UNITED STATES PATENT AND TRADEMARK OFFICE

10/798,450

Office Action Summary	Application No. 10/798,450	Applicant(s) NOWAK, PIOTR	
	Examiner THEODORE J. STIGELL	Art Unit 3763

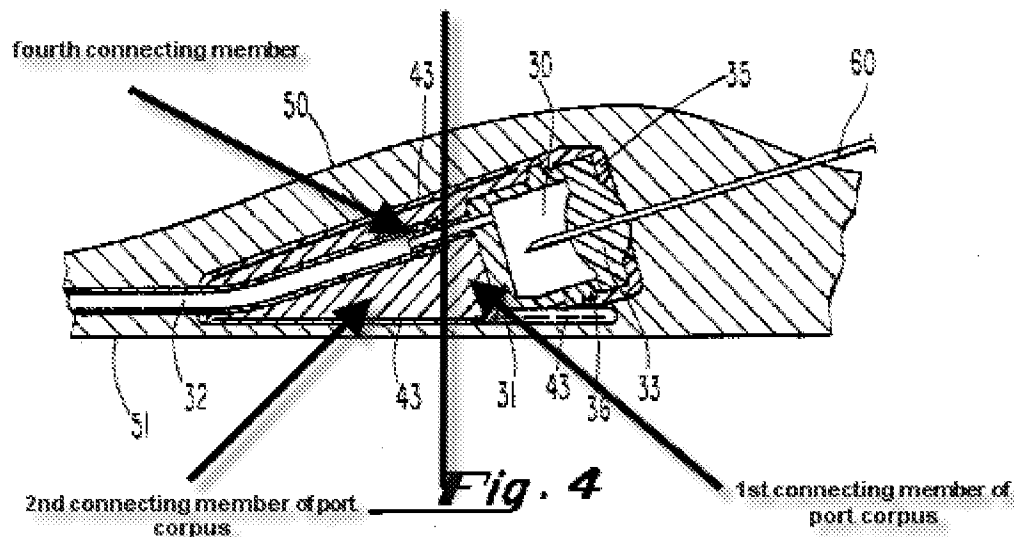
Claims 1-2, 16, 18, 20 and 29 are rejected under 35 U.S.C. 102(b) as being anticipated by Dalton (4,781,695). Dalton discloses a subcutaneous port (20) comprising a port corpus (40) elongated about an axis and comprising an inlet defining an opening at one end of the port corpus, an outlet having an outlet opening at a lengthwise opposing end of the port corpus, and a chamber defined therebetween, one of the inlet and the inlet opening comprising a first connecting member (see figure below) and one of the outlet and the outlet opening comprising a second connecting member (see figure below), the inlet opening and the outlet opening being the only

openings of the port corpus in communication with the chamber, a septum (33), a removable septum retainer (35) comprising a third connecting member being removably engaged with the first connecting member so as to dispose the septum in a position to occlude the port corpus inlet opening, and a removable conus (31) extending along the axis, the removable conus comprising an inlet end having an inlet opening at one end of the removable conus, an outlet connector having an outlet opening at an opposing lengthwise end of the removable conus, and a channel extending therebetween, the removable conus inlet end further comprising a fourth connecting member (see figure below) being removably engaged with the second connecting member, wherein the port corpus inlet is canted inwardly along the axis of the port corpus, and wherein the port corpus, septum, septum retainer, and conus are engageable to form a port assembly having a substantially slender overall profile for implantation under the skin of an animal, and further comprising a catheter (32) connected to the conus.
